REPORT OF THE EXECUTIVE OFFICER
State Allocation Board Meeting, February 22, 2012

SCHOOL DISTRICT DATA	
School District: .....SEQUOIA UNION ELEMENTARY	County:.....TULARE
Application Number:..... 50/72116-00-001	School Name:..... SEQUOIA ELEMENTARY
Total District Enrollment:.....338	Project Grade Level: K-8
Financial Hardship: ..... YES

To present the District's request for approval of its new construction project, which includes a Use of Grants (UOG) for Minimum Essential Facilities (MEF) pursuant to School Facilities Program (SFP) Regulation Section 1859.77.3.

BUILDING 100
FLOOR PLAN

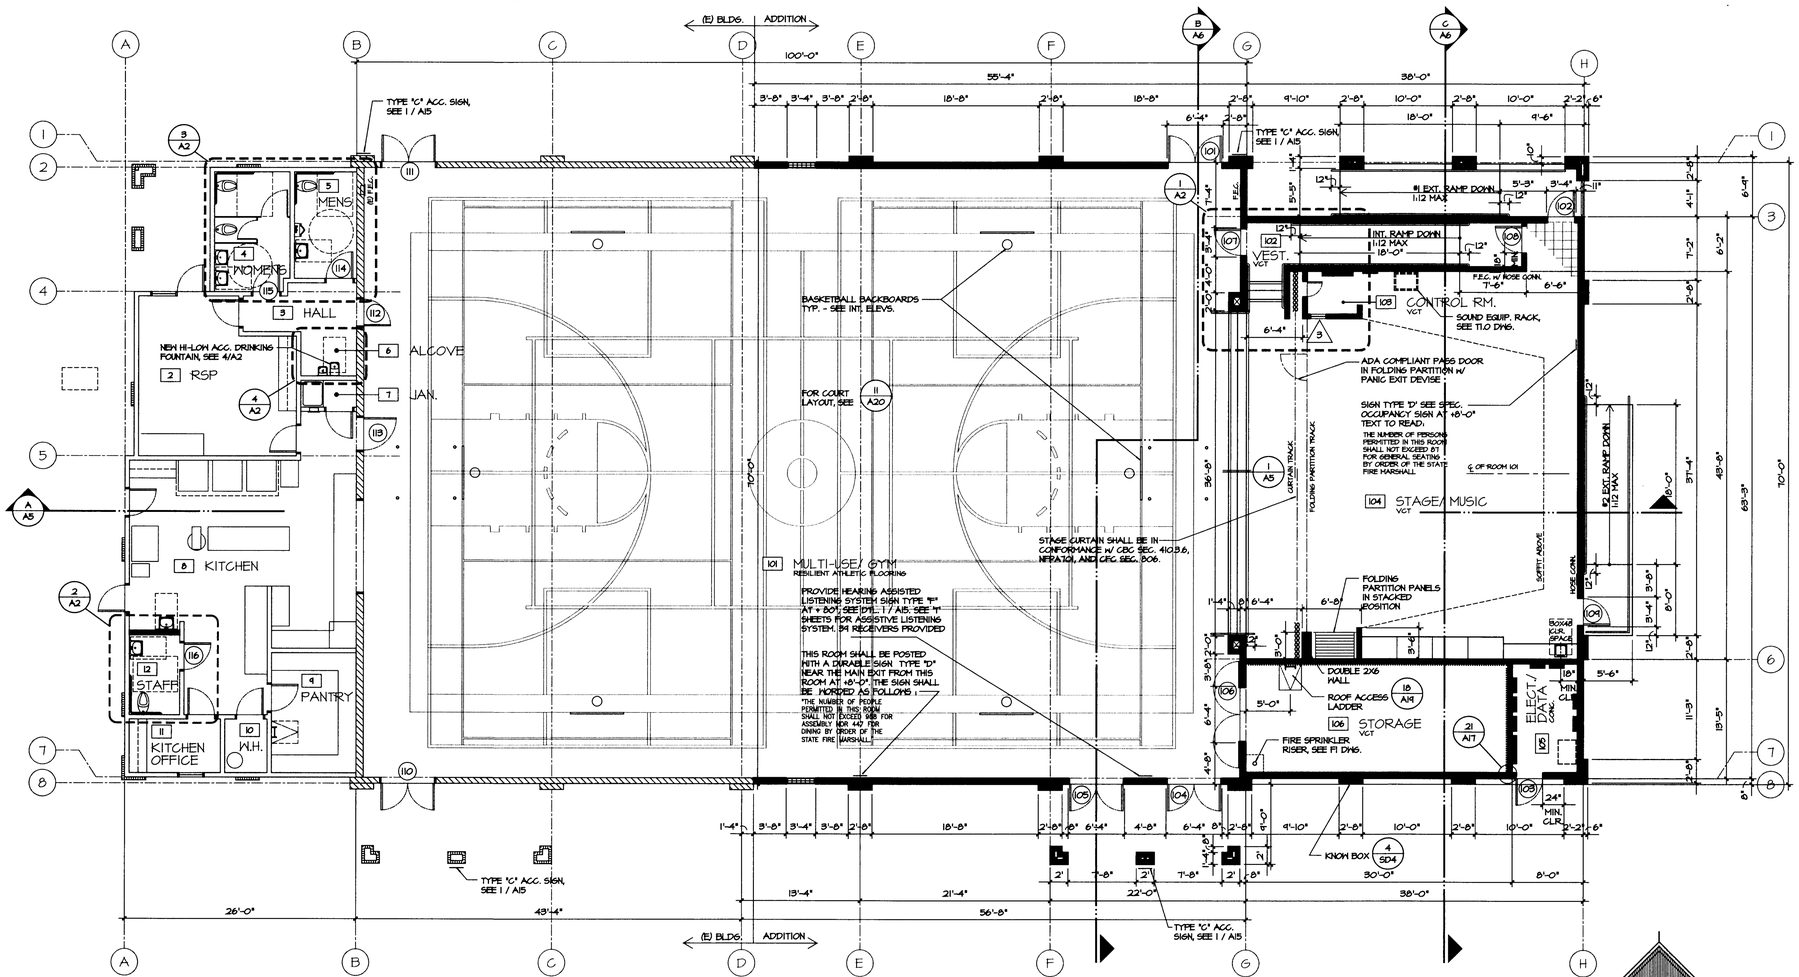
The District submitted an updated CDE Final Plan Approval Letter dated December 21, 2011 to the OPSC that classifies the addition as a gym/multipurpose room (Attachment D). The CDE letter indicates that the project is an expansion of the existing multipurpose room and recognizes that the project is constructing a hybrid facility that would serve as both a multipurpose room and a gymnasium. Based on this revised information, Staff is unable to conclusively determine that the scope of work qualifies as a gymnasium within the current regulations.

The existing multipurpose room was originally built to allow for a future addition. The building has one wooden (false) wall originally designed to be removed once the District was ready to proceed with an addition to the building. Even though the District is adding 3,873 square feet of designated gymnasium space, the existing multipurpose room and gymnasium addition will not be independent of each other. The 3,127 square feet of existing multipurpose space will be used to house part of the gymnasium floor area. As a result, the addition and existing building space are intertwined and cannot be viewed as separate facilities.

As the gymnasium addition cannot be separated from the existing multipurpose room, Staff classifies the new square footage as an addition to the existing multipurpose room. Based on SFP Regulation Section 1859.77.3, the District's current multipurpose room is considered adequate. If there is an existing facility, the existing square footage must be inadequate. To be classified as inadequate the existing square footage must be less than 60% of the square footage necessary for the current enrollment of the site plus the capacity of the proposed project. The calculation is as follows:

In considering this Item, the SAB approved the alternative option of classifying the gymnasium and multipurpose as independent entities and to fund the project. In addition, it was clarified that the SAB would be funding the gymnasium portion of the expansion project not the multipurpose portion.
